Service Bulletin

Faulty Door Sensor Setup Leading to Charging Disruptions

Power Link 1000

Bulletin Published: December, 2025

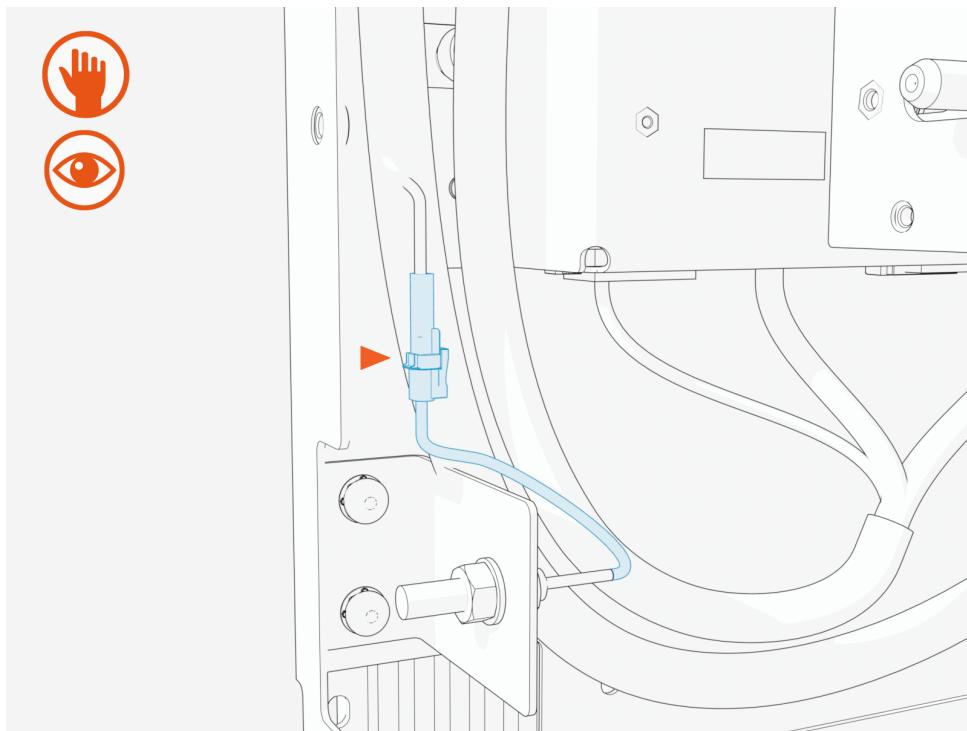
- The magnet is oriented backwards, where potting side is facing the sensor.
- The magnet is too far from the reed sensor
- The reed sensor Molex connector is loose or damaged

1. Make sure the magnet and sensor are aligned in the correct orientation, refer to the following image.

- (a) Incorrect:** The potted side of the magnet faces the threaded side of the sensor.
- (b) Incorrect:** The magnet and sensor are misaligned, their threaded ends do not face each other.
- (c) Correct:** The threaded side of the magnet and the threaded side of the sensor face each other and are properly aligned.

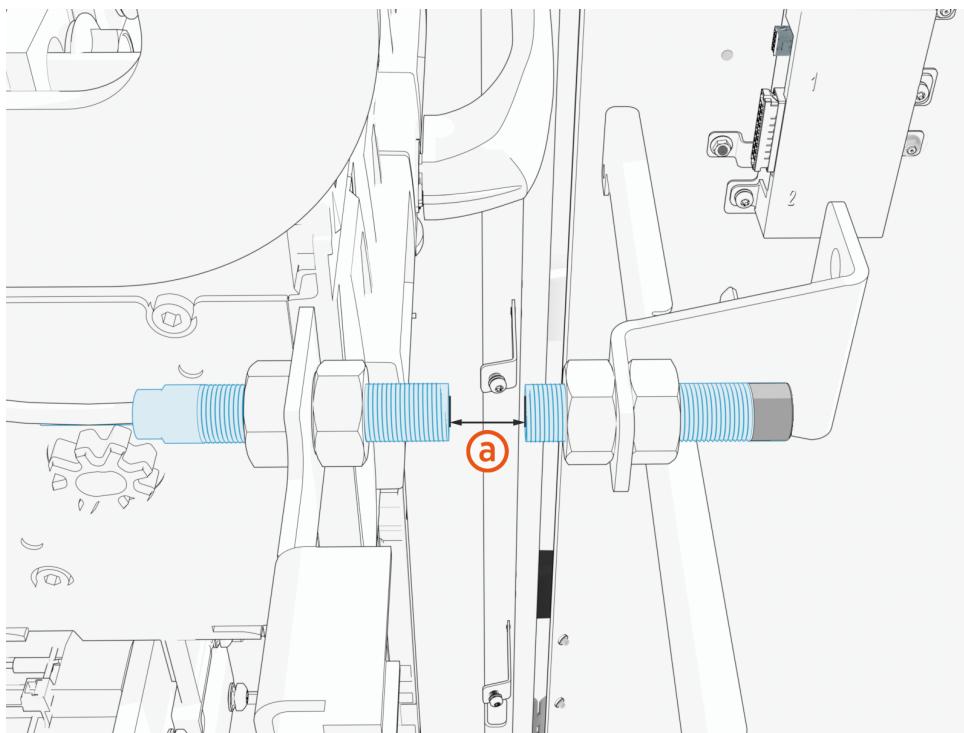
2. Inspect the Molex connector for bent pins, corrosion, or loose fit.

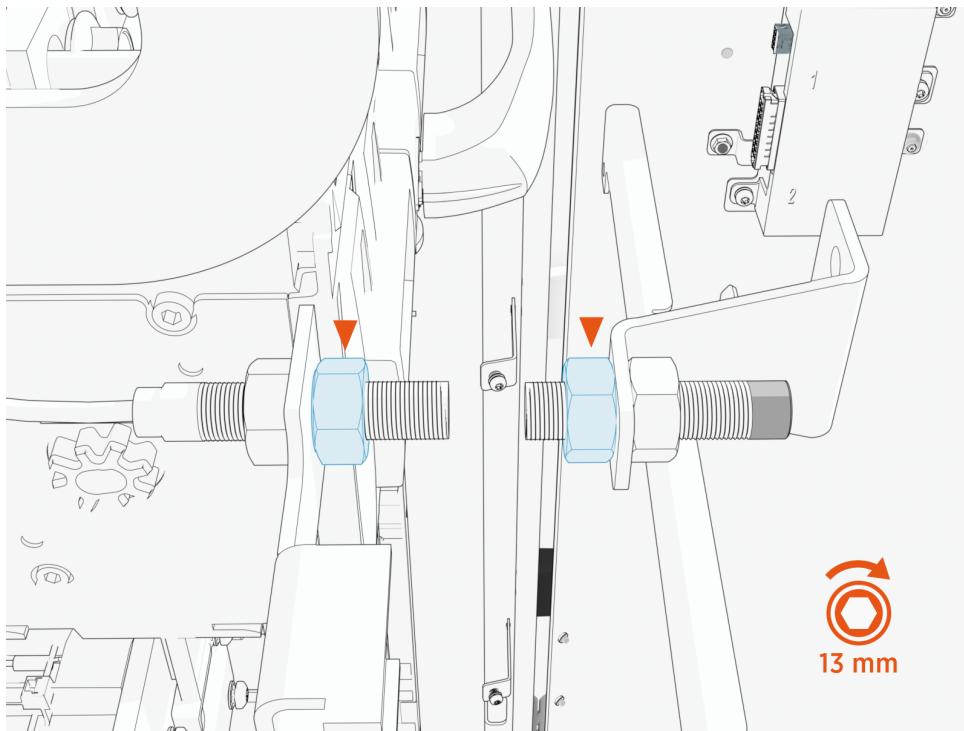
3. Measure the gap **(a)** between the threaded sides of the sensor and magnet, and ensure the gap is less than 10 mm and as close as possible.

NOTE: If needed, replace standard M8 nuts (x2) with the thin M8 nuts (x2) on both sides of the magnet to reduce the gap **(a)**.

6. Use the 13 mm socket, torque the nuts to **1.13 Nm (10 in-lb)**.
